## Section 2: Massing and Architecture

2201 N PERSHING DRIVE

**2201 N Pershing Dr  
History of Density/Massing Reductions**

JULY 30, 2007

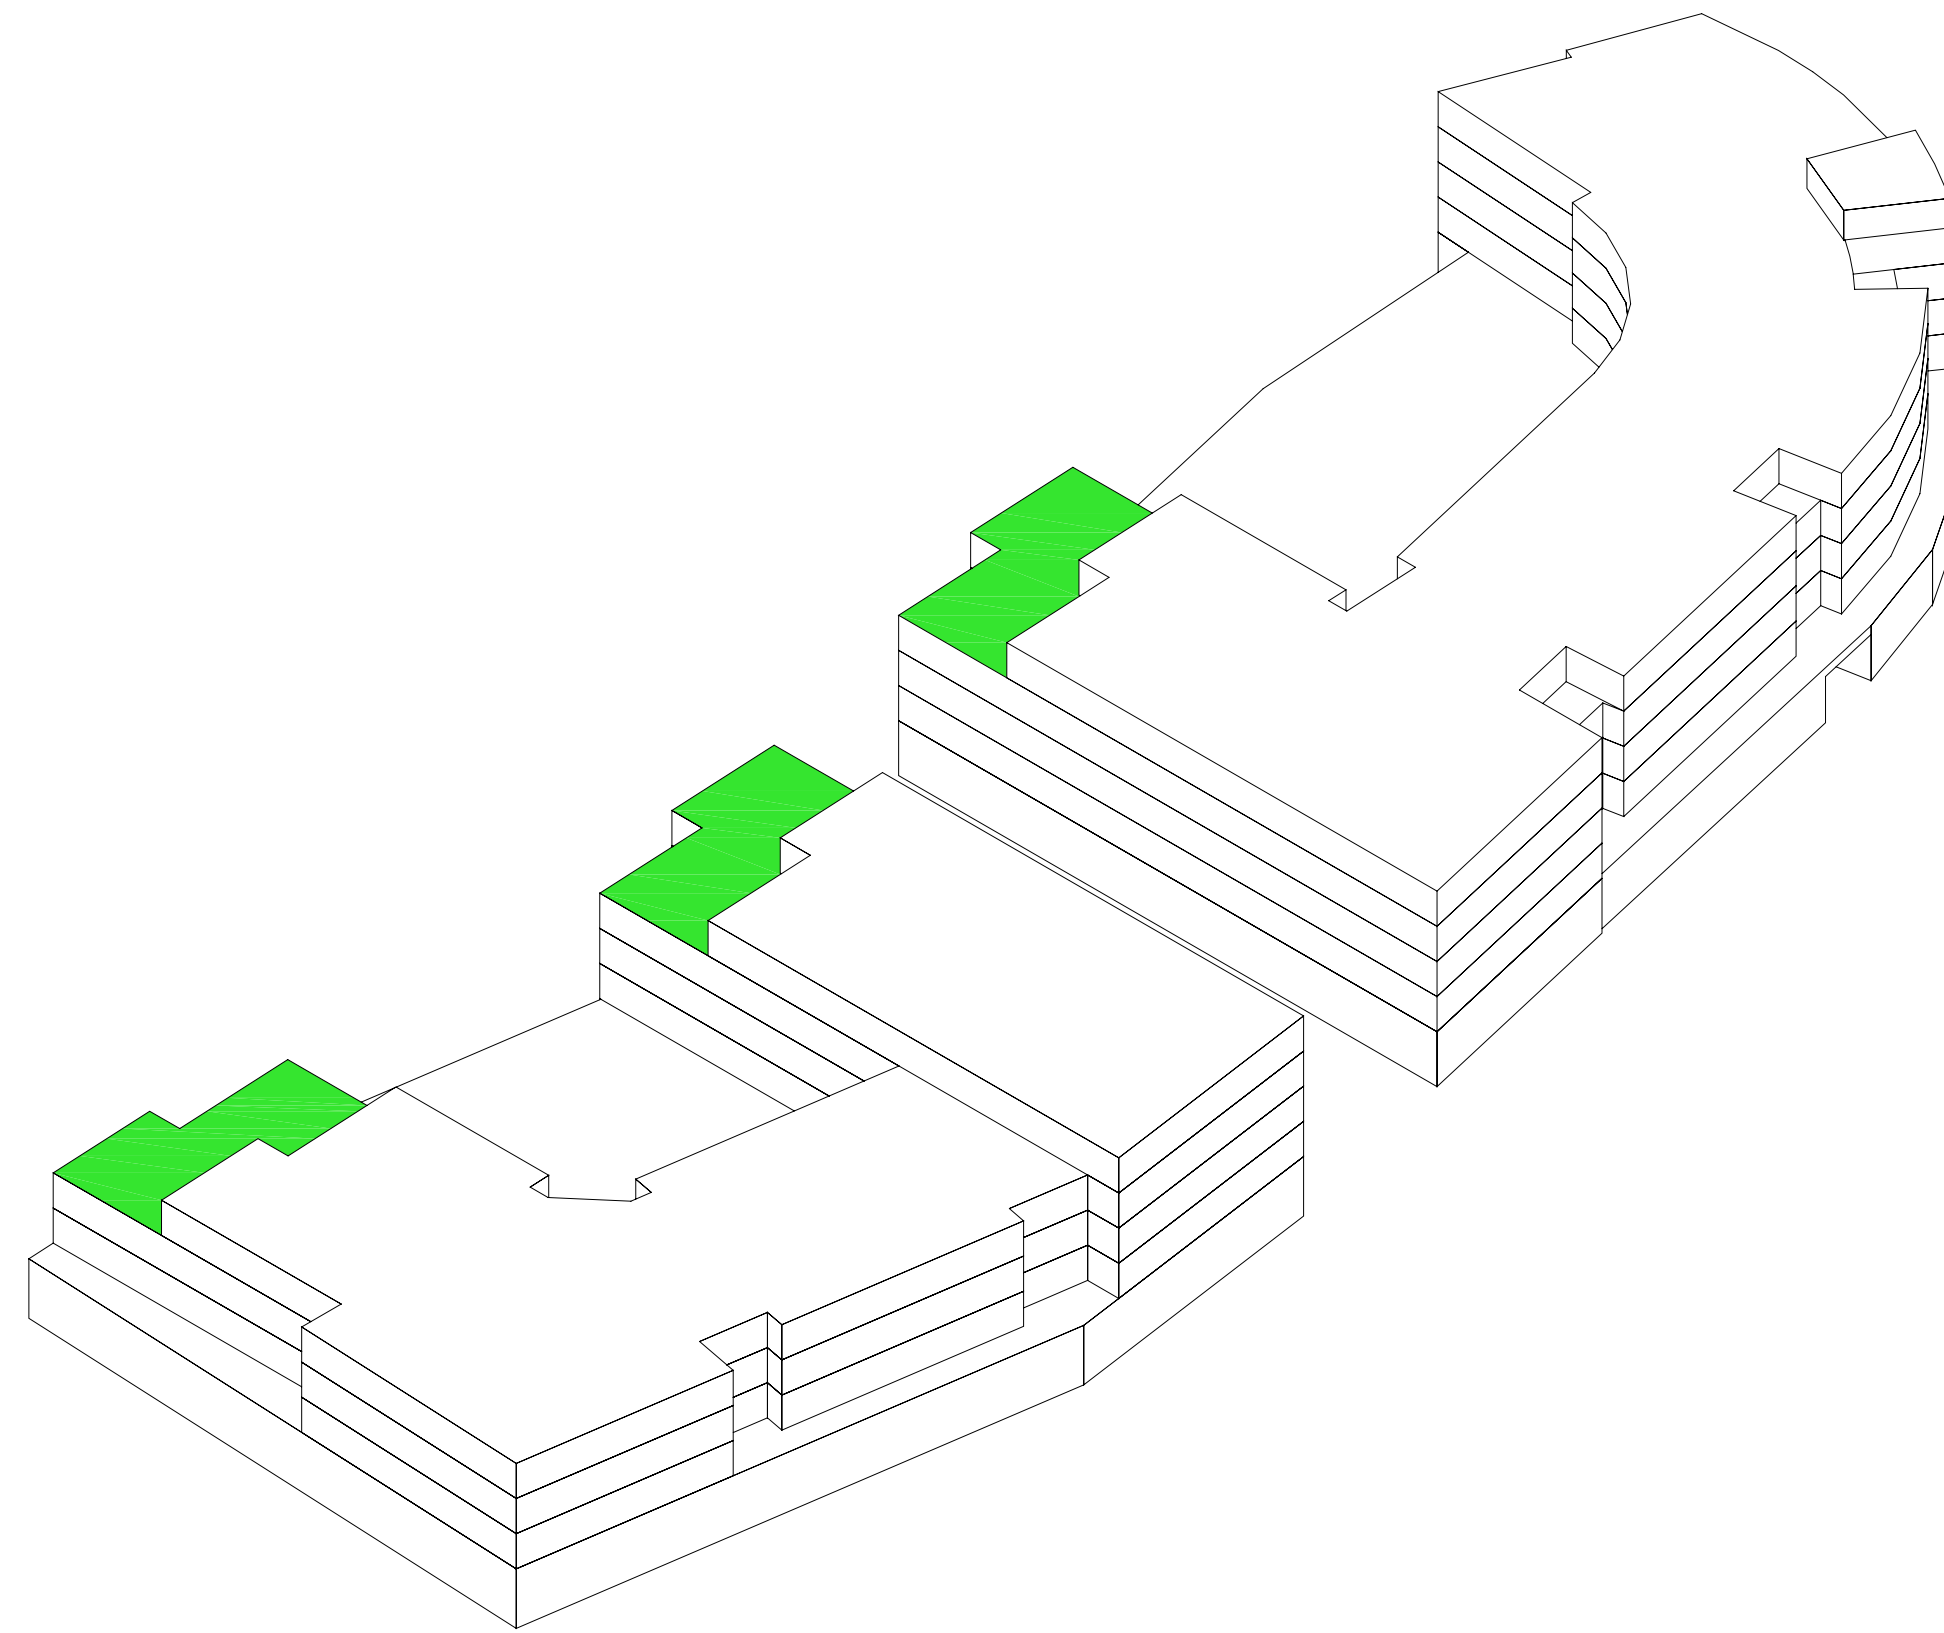
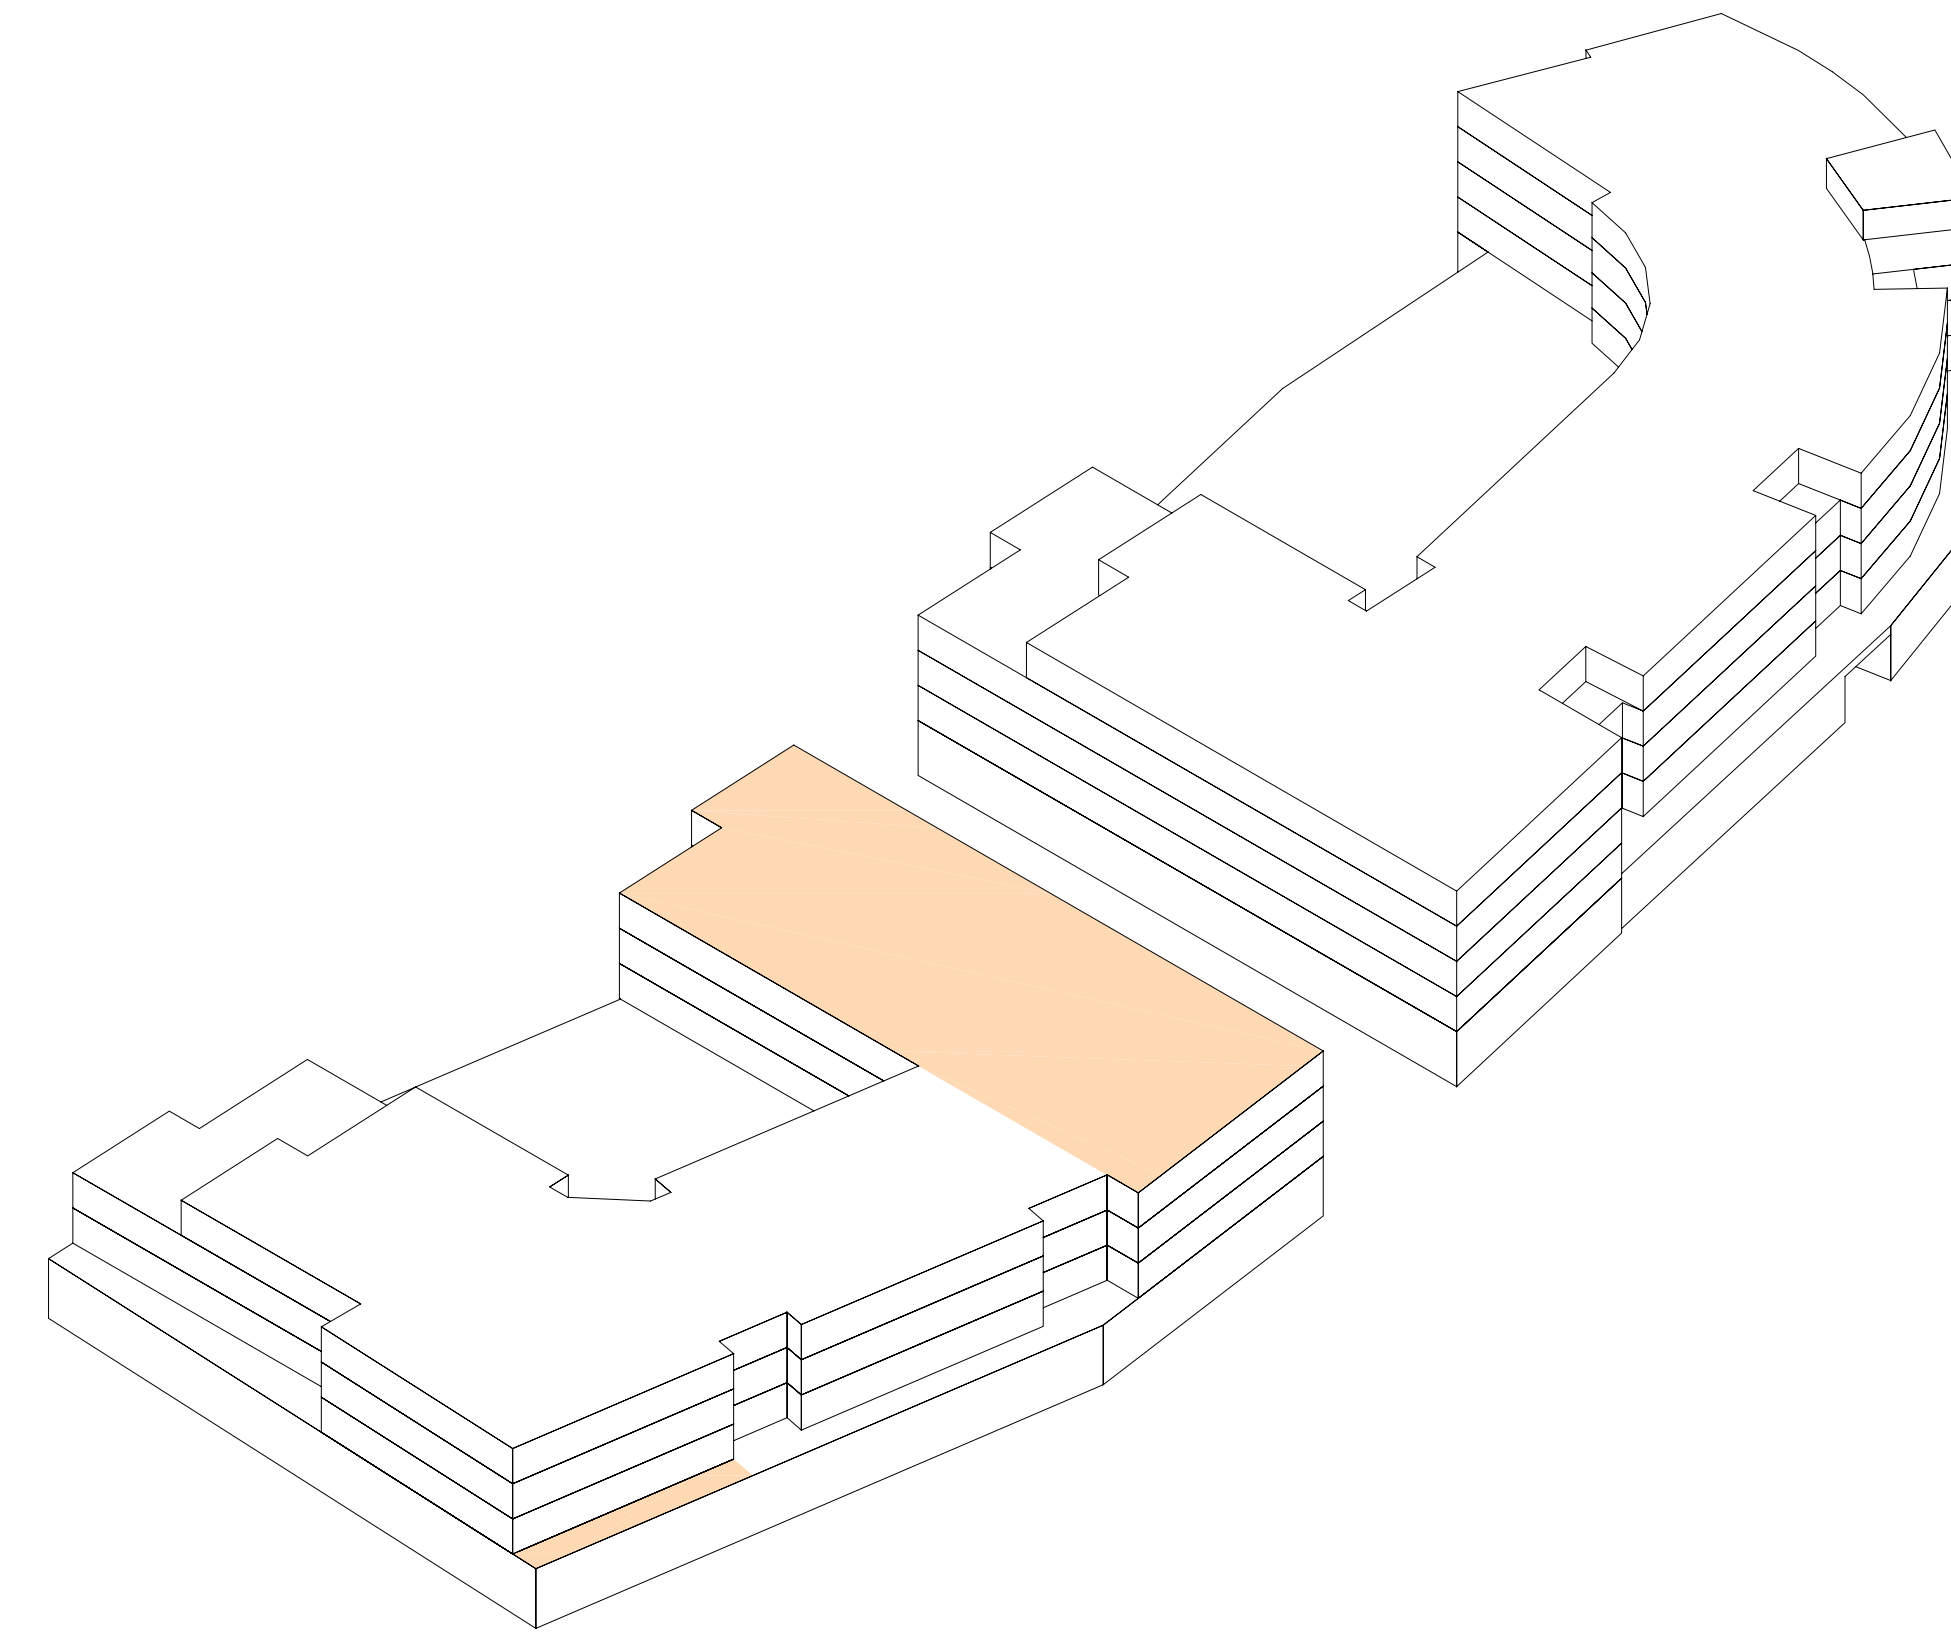
#### **Is the proposed massing compatible with the surroundings?**

**Can the massing be better modulated to create a more varied building form?** There have been a number of changes to the massing of the buildings throughout the review process which have served to reduce the overall scale and intensity of the project. In summary, these changes include the following:

The proposed building massing is comparable to that of surrounding buildings. The Sheffield Court buildings to the north present a continuous building façade of approximately 973 feet along Arlington Blvd, and the building directly to the east on Fort Myer has a length of 301 feet and a width of 128 feet. Our largest building has a length of 302 feet and a width of 80 feet. Furthermore, some of Sheffield Court's buildings rise 4-5 stories above grade along Arlington Boulevard.

- Elimination of the proposed bridge between the two buildings, which reduced the mass and also opened up the view corridor from Wayne Street looking north through the site to the Sheffield Court clubhouse building and cupola.

- Elimination of the fifth floor from Building #1 (the building on the western half of the site).
- Introduction of tiering along the northern property line towards Sheffield Court, with the top floors pulled back 36 feet in certain locations.

- Additional stepping back of the residential use behind the retail base, resulting in setbacks of approximately nine feet on the Pershing Drive façade and seven feet along the western façade of Building #1 (facing Barton Street) to create additional layering of the massing along the streetscape as experienced by pedestrians.

- Introduction of deeper setbacks (14 feet to 19 feet in depth) in five locations along the Pershing Drive frontages to create better building articulation in order to break up the total building mass into a series of smaller, discrete components. At the top floor, these setbacks are further tiered to between 19 and 25 feet in depth to create further articulation on the façade.

- Redesign of the “tower” element facing Arlington Boulevard as a prominent architectural feature for the project.

The net effect of all these reductions and modifications has been to eliminate approximately 34,185 square feet of proposed residential area from the project. This represents more than 14% of the total residential density from the original design. Overall, approximately 58% of the total building footprint is four stories or less if the courtyards above the retail parking are excluded from this calculation. If the courtyards are included, then the proportion of the project at four stories or less increases to 68%.
